**MULTICULTURAL ALLIANCE FOR A SAFE ENVIRONMENT (MASE)  
SCOPING COMMENTS FOR THE NRC CHURCHROCK MINE WASTE DISPOSAL EIS**

**Prepared by**  
**Wm. Paul Robinson and Chris Shuey**  
**Southwest Research and Information Center**  
[www.sric.org](http://www.sric.org)  
PO Box 4524  
Albuquerque, NM 87106  
email: [sricpaul@gmail.com](mailto:sricpaul@gmail.com) and [sric.chris@gmail.com](mailto:sric.chris@gmail.com)

**April 19, 2019**

Flood waters in Pipeline Arroyo at Red Water Pond Road bridge (L), downstream at the Pipeline Road crossing (R), August 2012

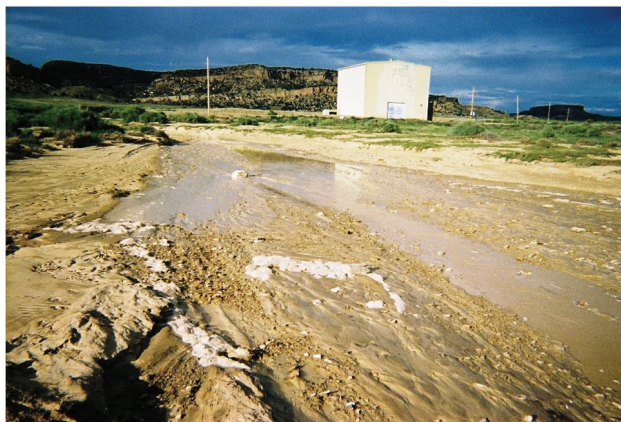
As we showed at the March 19 scoping meeting, flash floods have been commonplace in the Pipeline Arroyo and in and around the UNC restricted area over the past 20 years. Transcript I at 81-83 (Shuey Statement). Photos by RWPRCA members and SRIC staff from 2006 and 2012 illustrate the intensity of flood waters surging through the Pipeline Arroyo just north of the tailings impoundment, and water ponding in the same area outside of the stream channel. These are just a sampling of the many photos we have that reflect recent flood events, rather than the 40-year-old data offered by the Applicant.
